Addendum CC-03

Milford Public Schools
Jr-Sr High School Addn. & Renovation
301 G Street
Milford, NE 68405

Item No. A1 Civil Work - Sheet C2.1 Removal Plan

RE: Milford Jr.-Sr. High School Addition
Milford, NE
E&A #P2018.264.002

REMOVAL PLAN
MILFORD PUBLIC SCHOOLS
JR. - SR. HIGH SCHOOL ADDN. & RENOVATION
 301 'G' STREET, MILFORD, NE 68405
 05/17/2019
C2.1
 CWP 18121

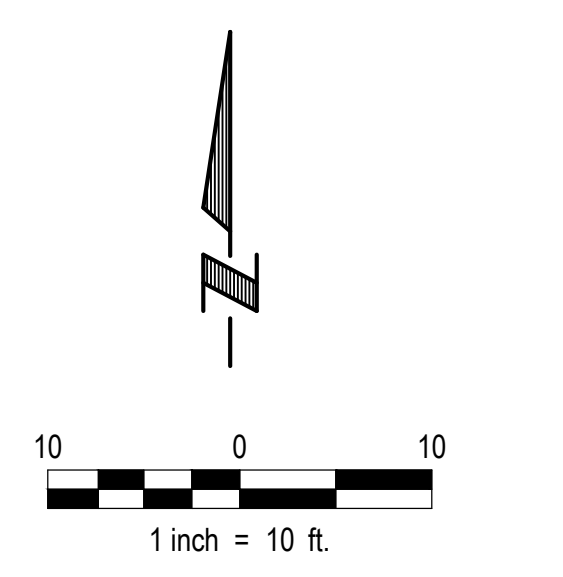
1. Accessible Routes: Existing sidewalk has been removed and replaced with a 5' sidewalk to provide an accessible route to the addition
2. Accessible ramps shall be on the east and west end of the sidewalks serving the new addition. Current ramps do not meet accessibility guidelines. Existing ramps east of the addition have been removed and replaced with an accessible depressed handicap ramp to provide access from the ADA parking stall.
3. The accessible parking stall shall be van accessible. A handicap stall and appropriate loading zone haven been added to the plan. The existing parking lot slopes currently accessibility guidelines so only striping and signage was necessary.

- A. See E&A Addendum 3, Responses to City Comments, attached hereto and dated 6/6/2019 for additional addendum items. This Sheet is Revised & Re-Issued per this Addendum.

PAVING AND LAYOUT PLAN
MILFORD PUBLIC SCHOOLS
JR. - SR. HIGH SCHOOL ADDN. & RENOVATION
301 'G' STREET, MILFORD, NE 68405

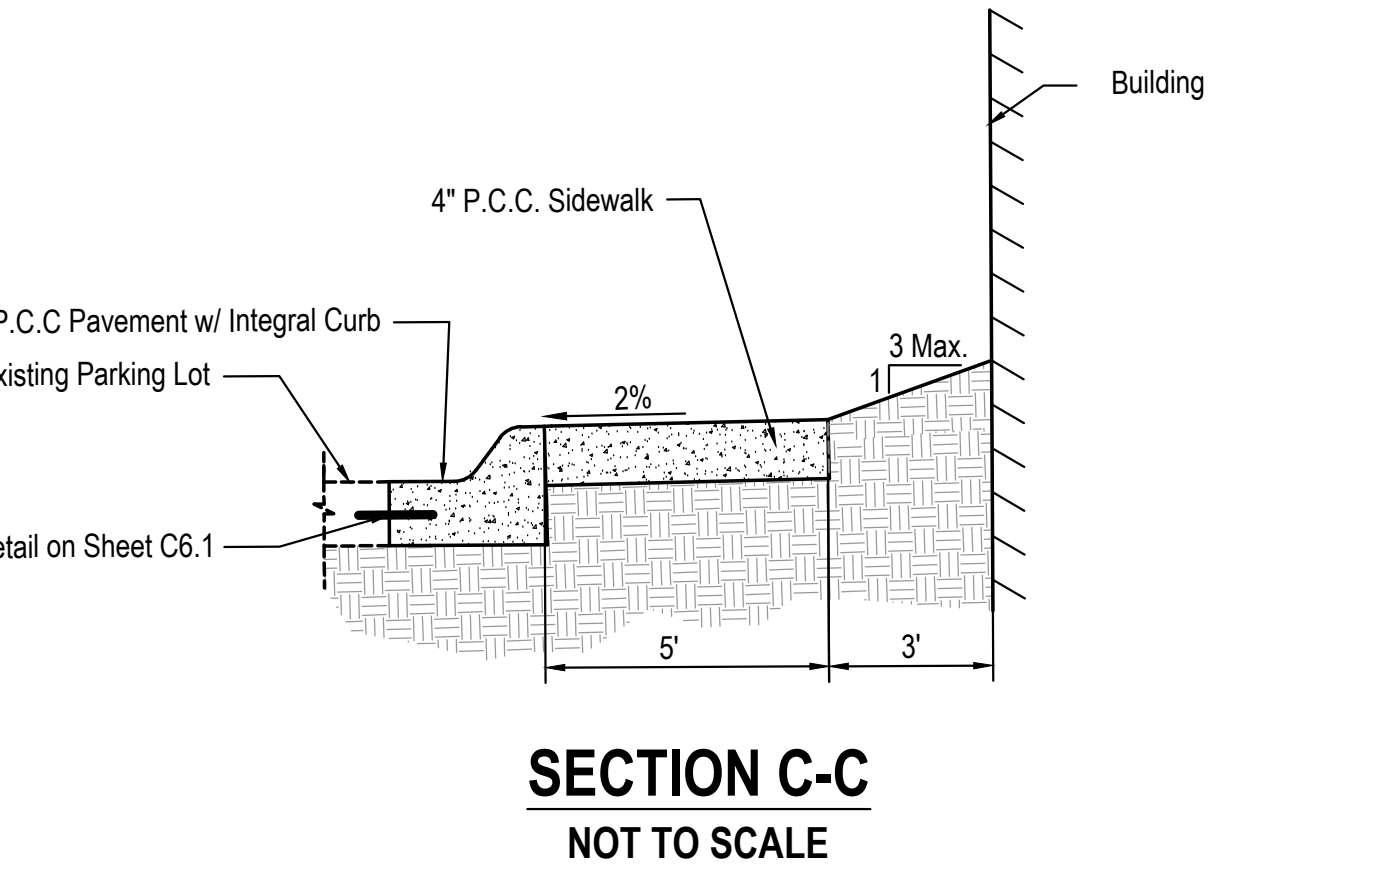
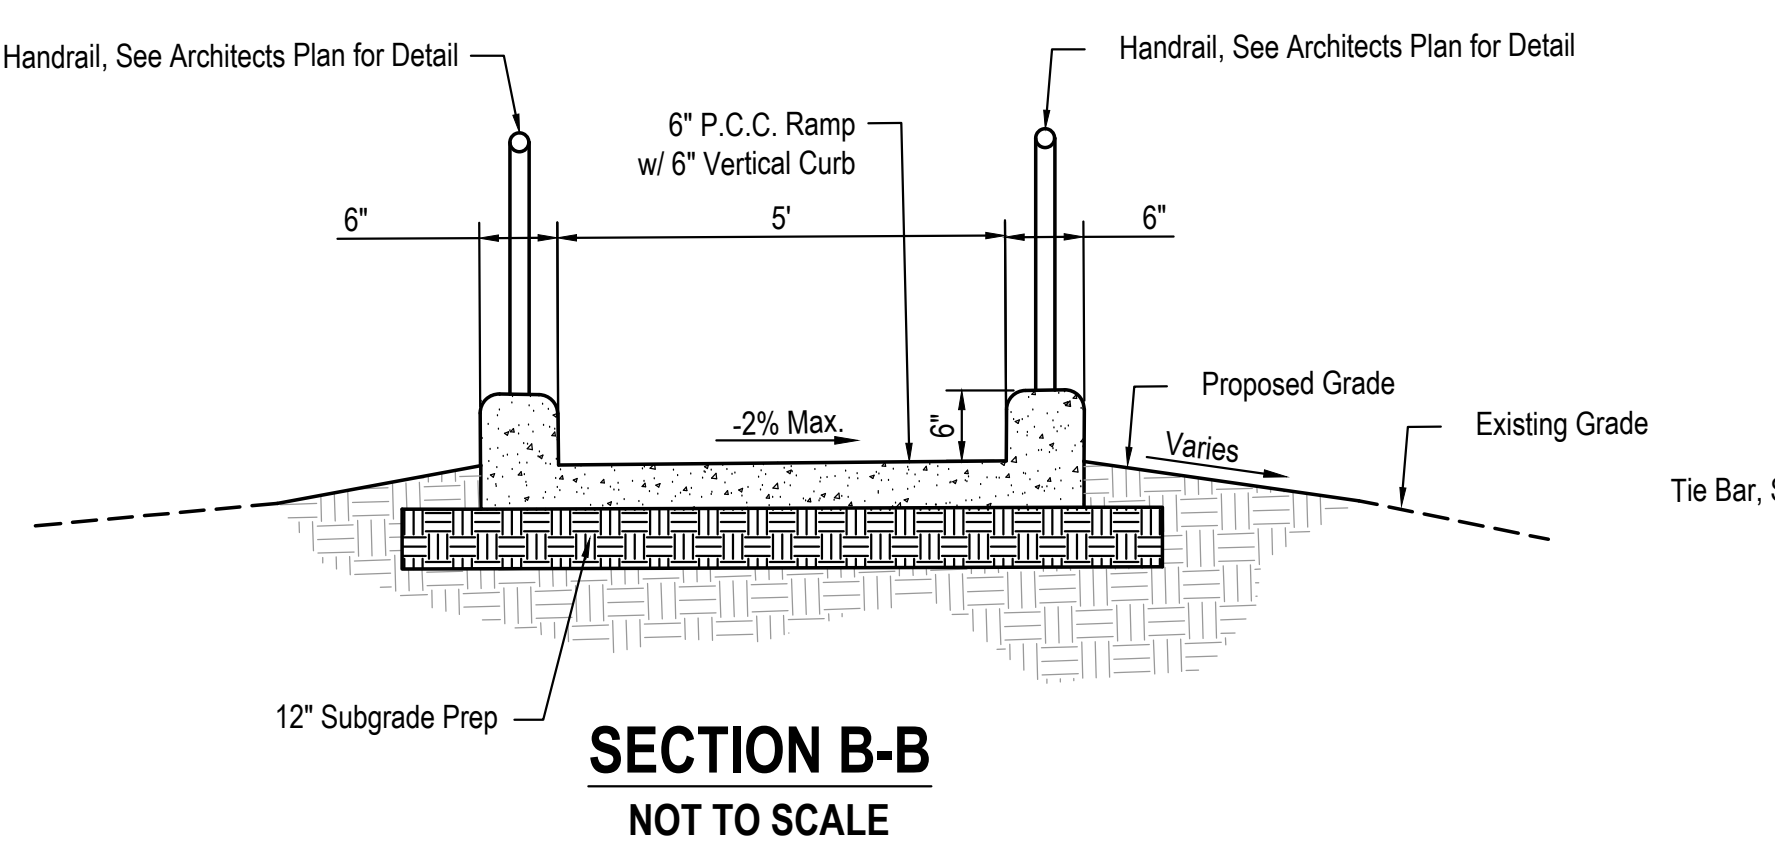
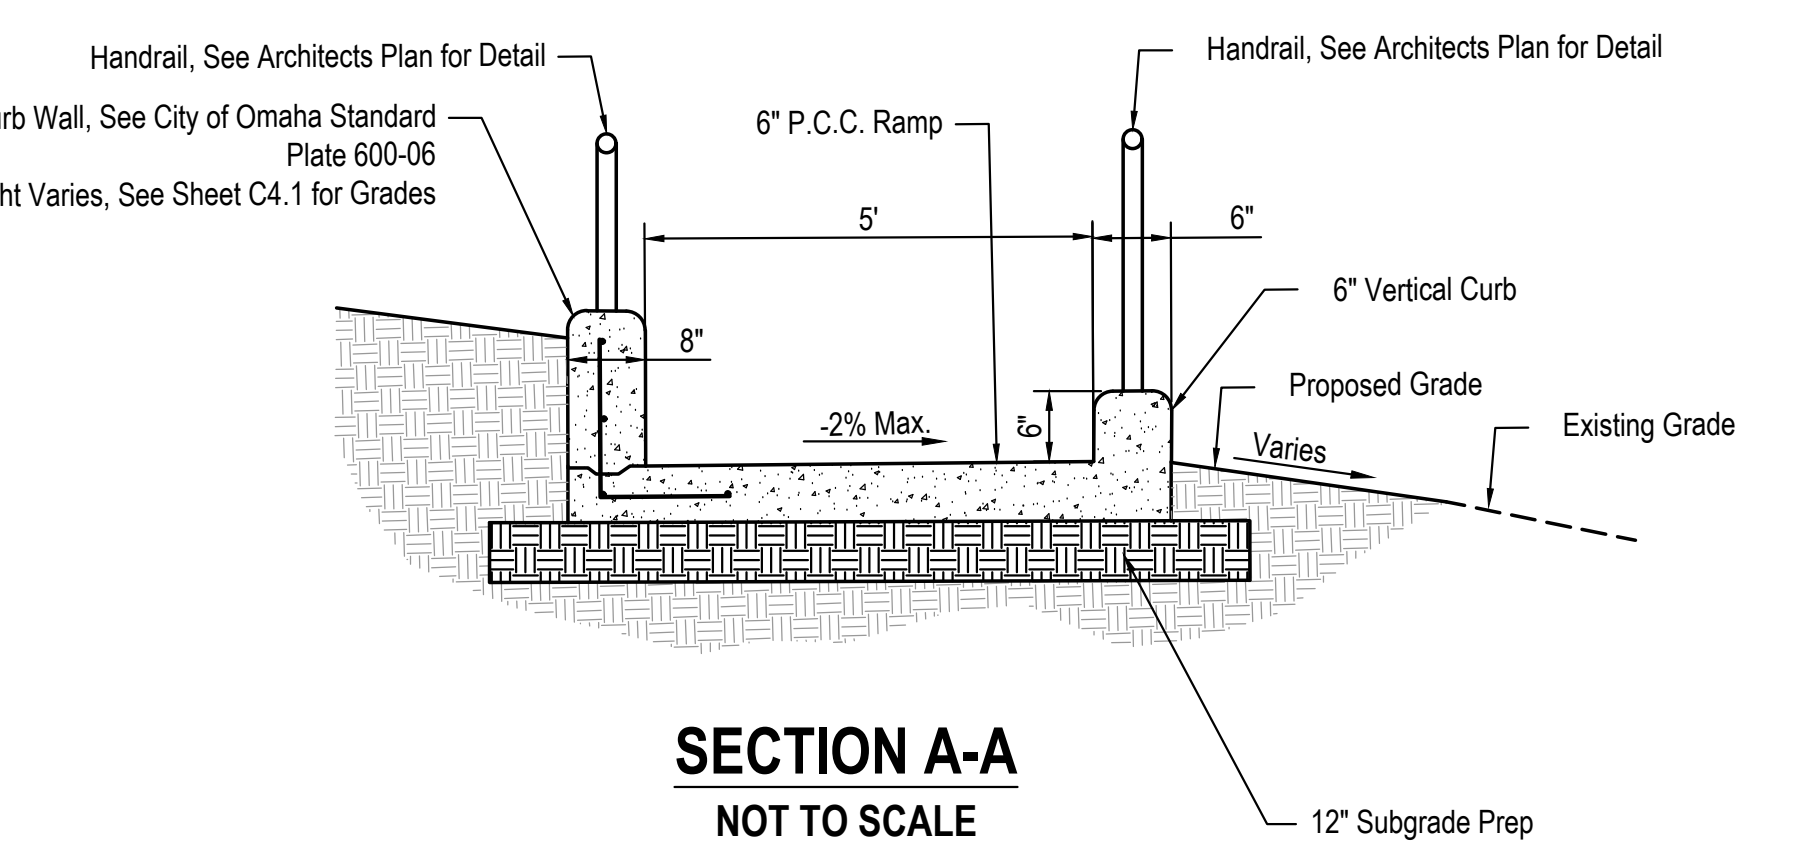
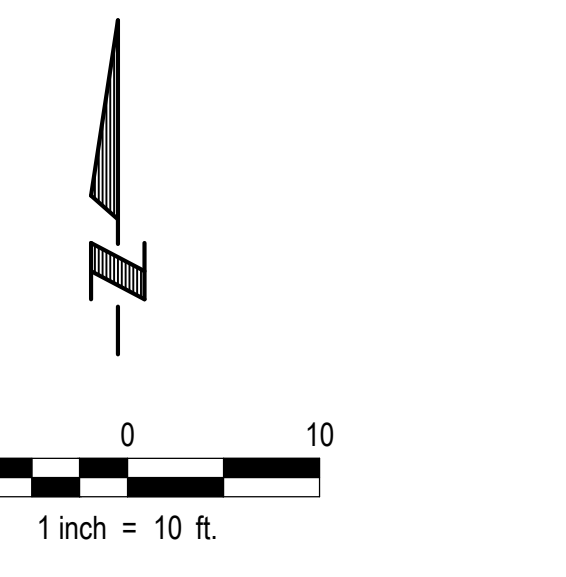
Item No. A2 Civil Work - Sheet C3.1 Paving and Layout Plan

- A. See E&A Addendum 3, Responses to City Comments, attached hereto and dated 6/6/2019 for additional addendum items. This Sheet is Revised & Re-Issued per this Addendum
